STANDARD DEPARTURE CHART-INSTRUMENT

RJOZ / OZUKI

INSTRUMENT APPROACH CHART

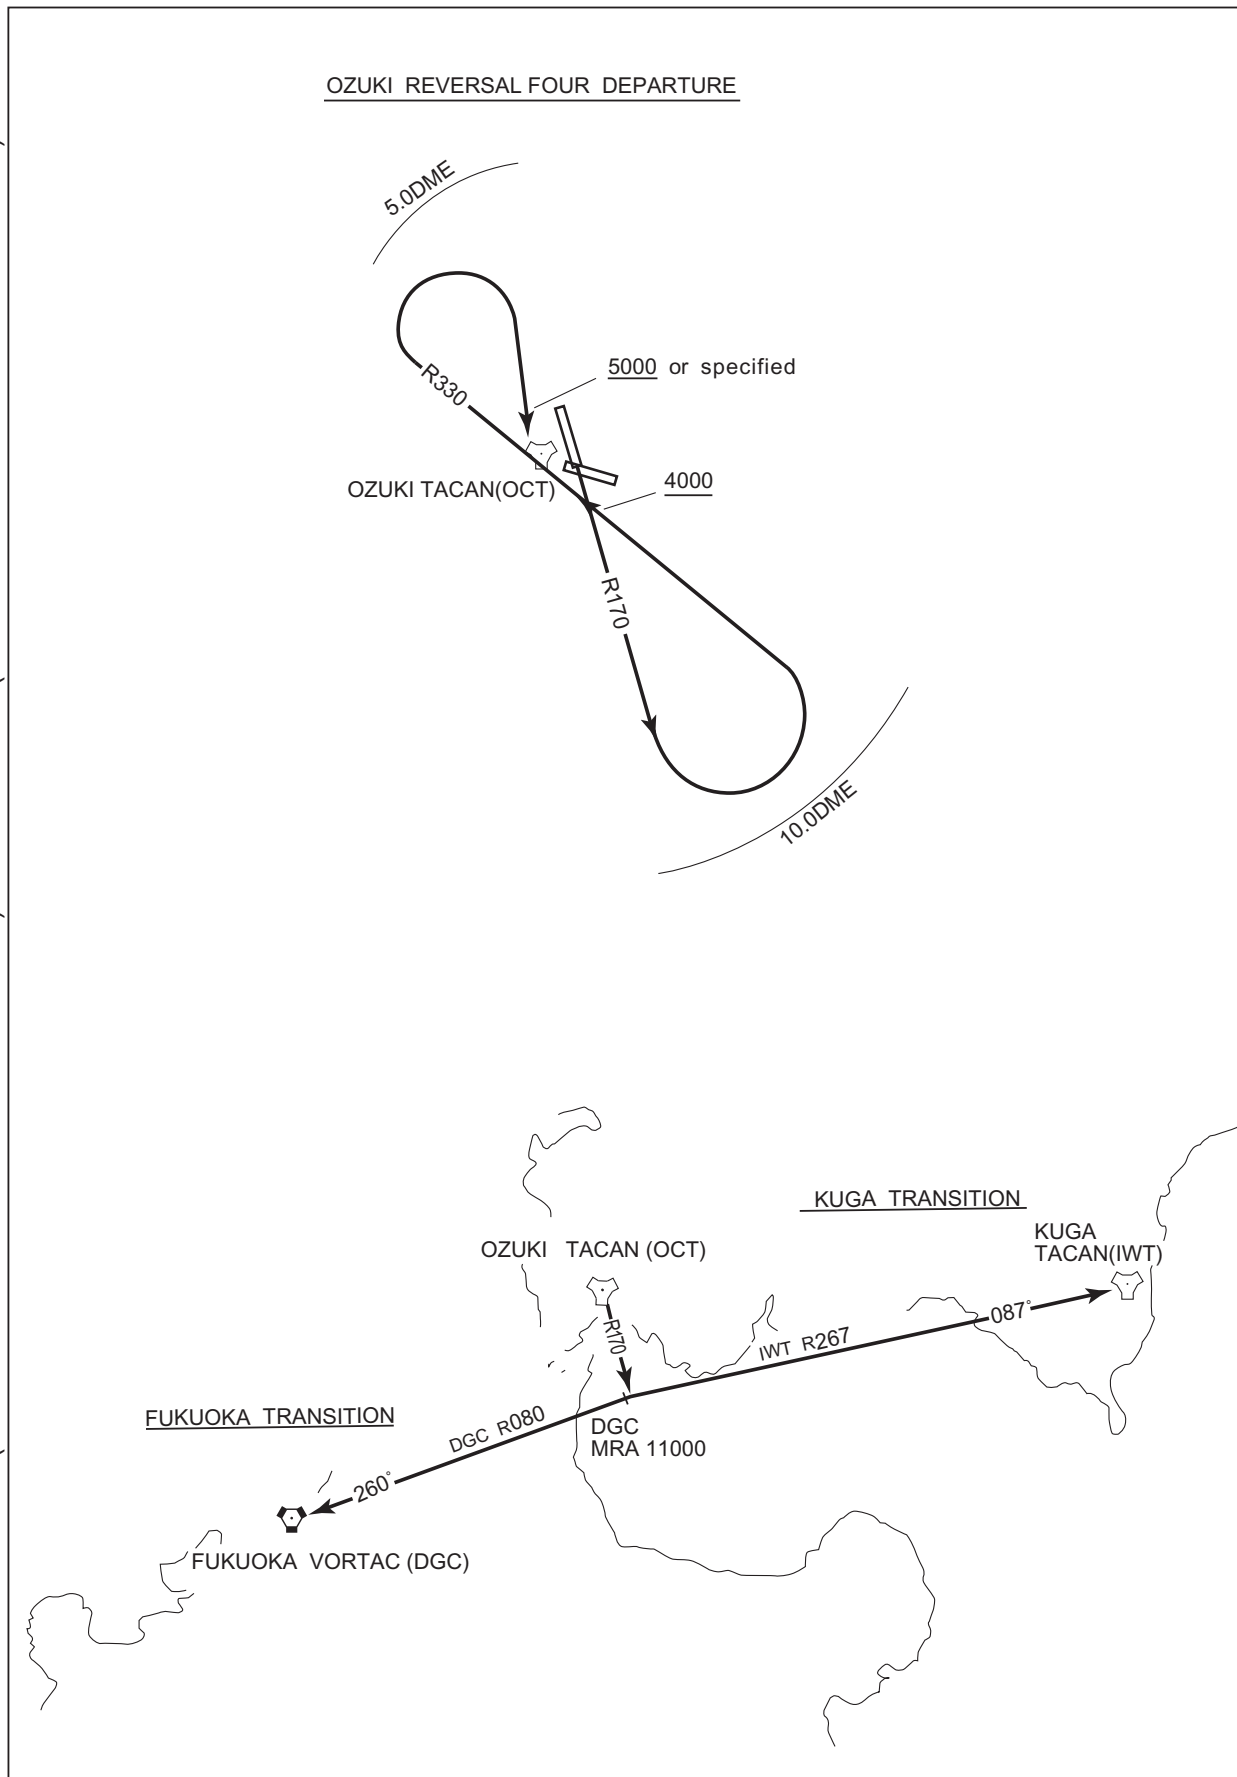
CHANGE : PROC course(OZUKI REVERSAL FOUR DEPARTURE). PROC renamed(OZUKI REVERSAL FOUR DEPARTURE). Note deleted.

CHANGE : PROC course(OZUKI REVERSAL FOUR DEPARTURE). PROC renamed(OZUKI REVERSAL FOUR DEPARTURE).

RWY 17: Climb via OCT R170, turn left to OCT TACAN within 10.0DME.

Then proceed via OCT R330, turn right to OCT TACAN within 5.0DME.

Cross OCT TACAN at or above 5000FT or specified altitude.

TACAN A

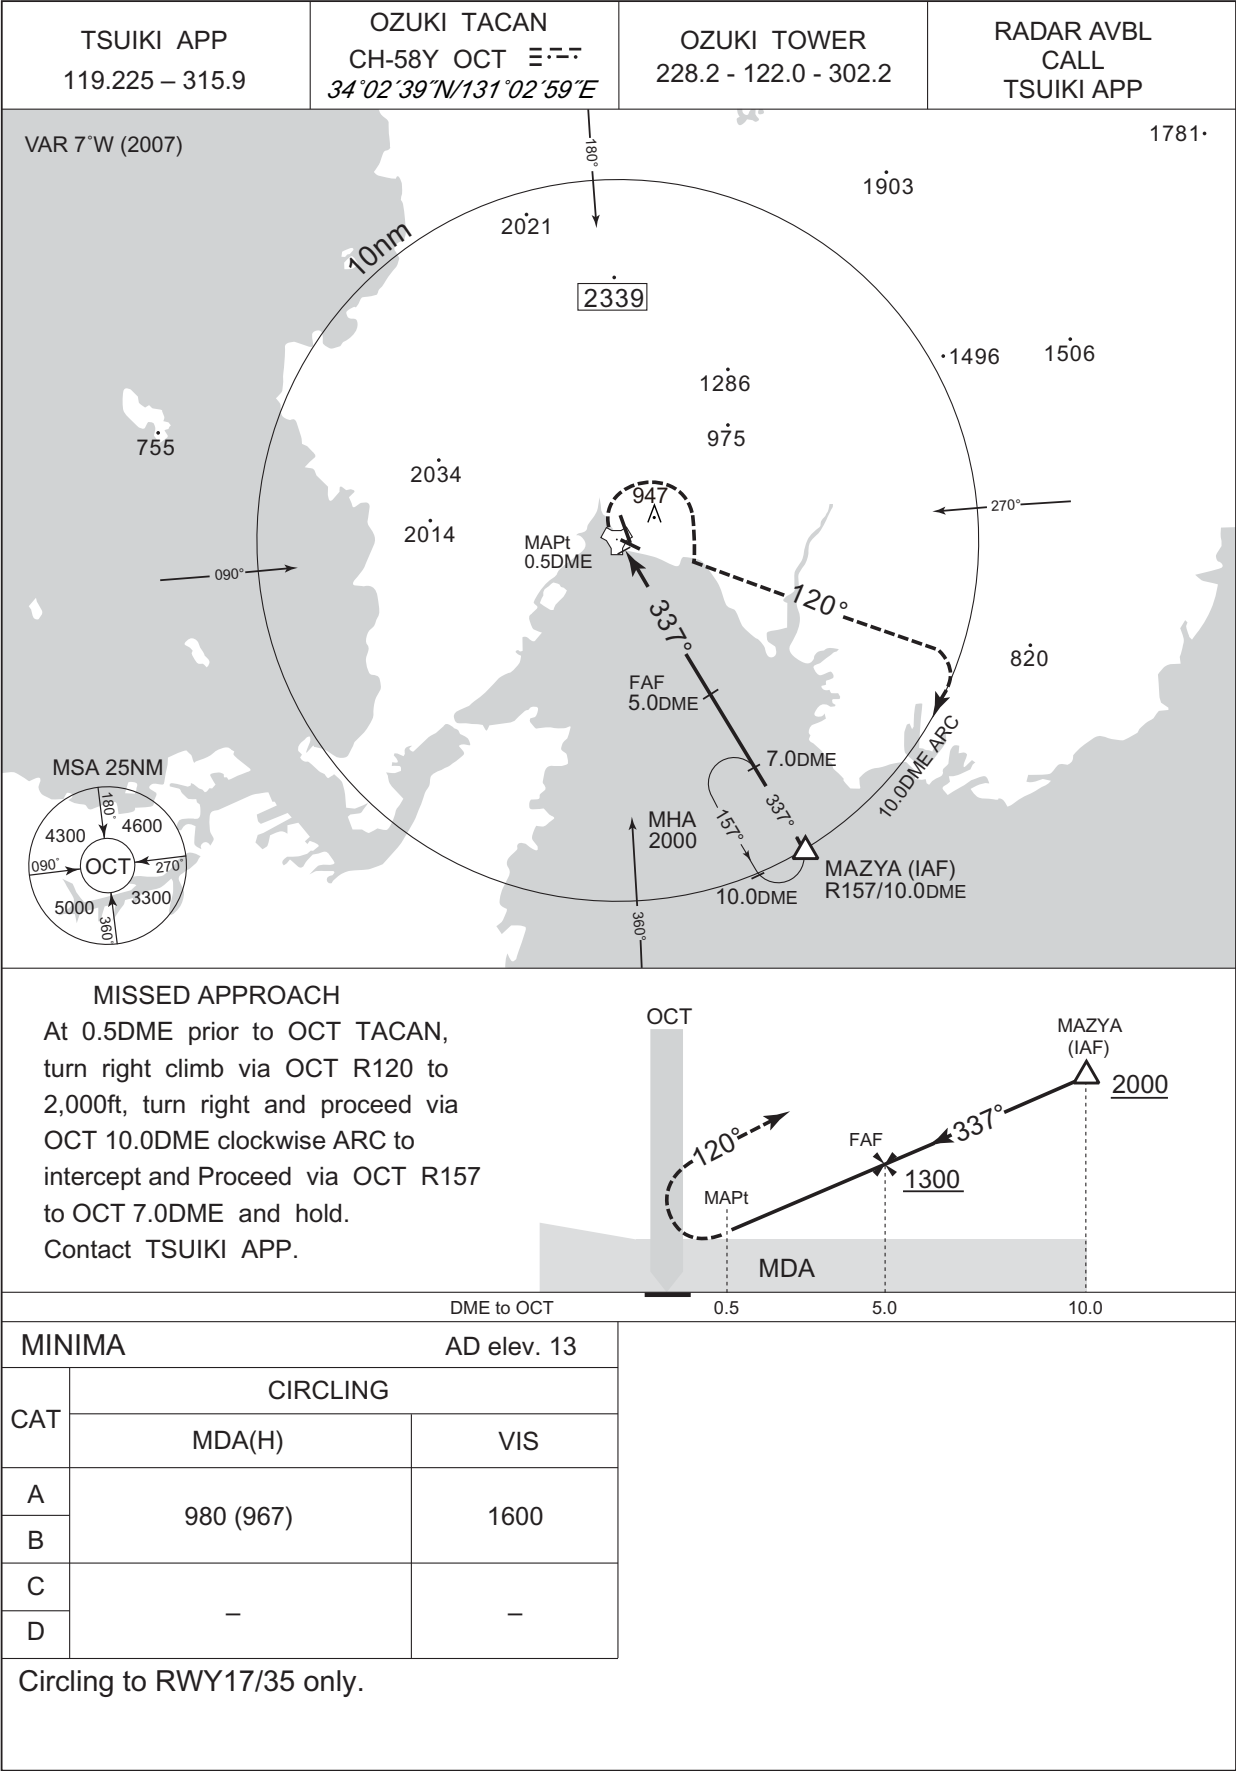
CHANGE : OBST. MHA. MINIMA for MDA(H). Circling restriction.

LDG CHART

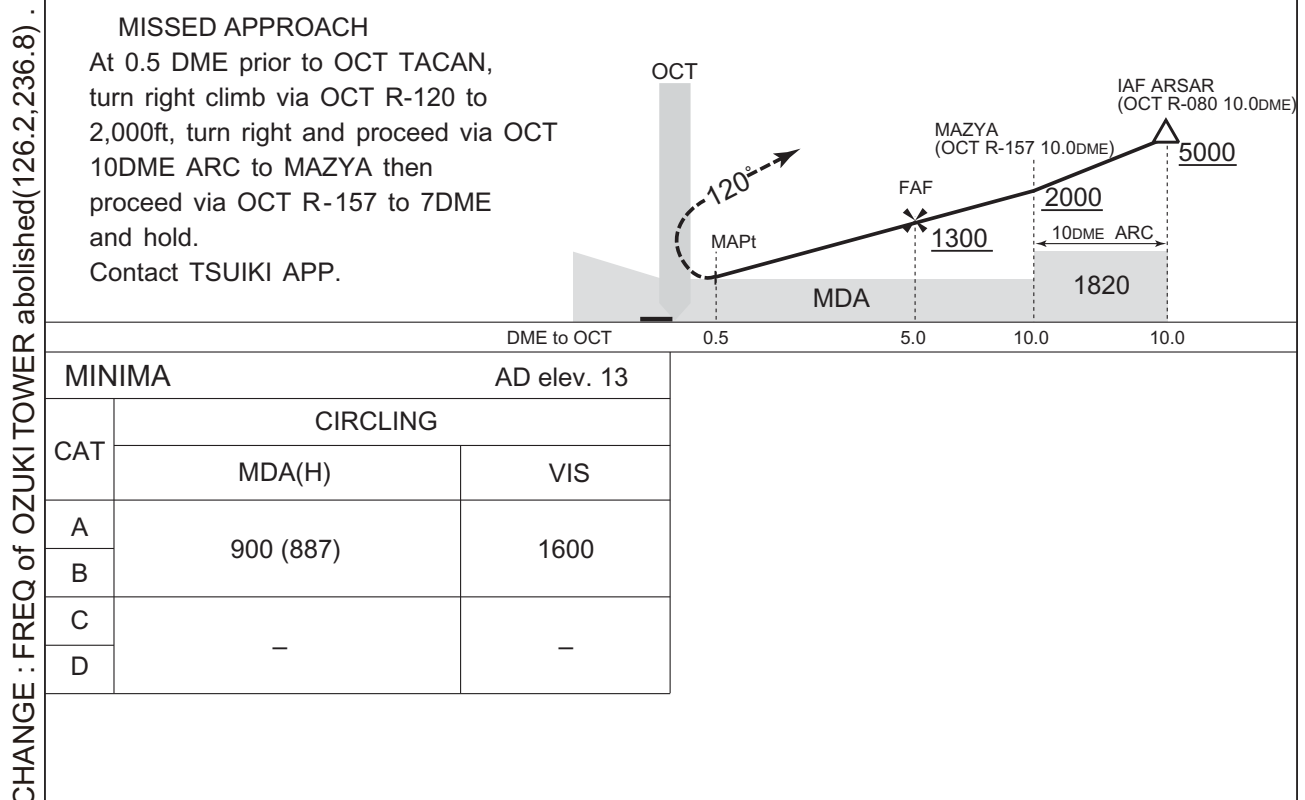
CHANGE : FREQ of OZUKI TOWER abolished(126.2,236.8) .
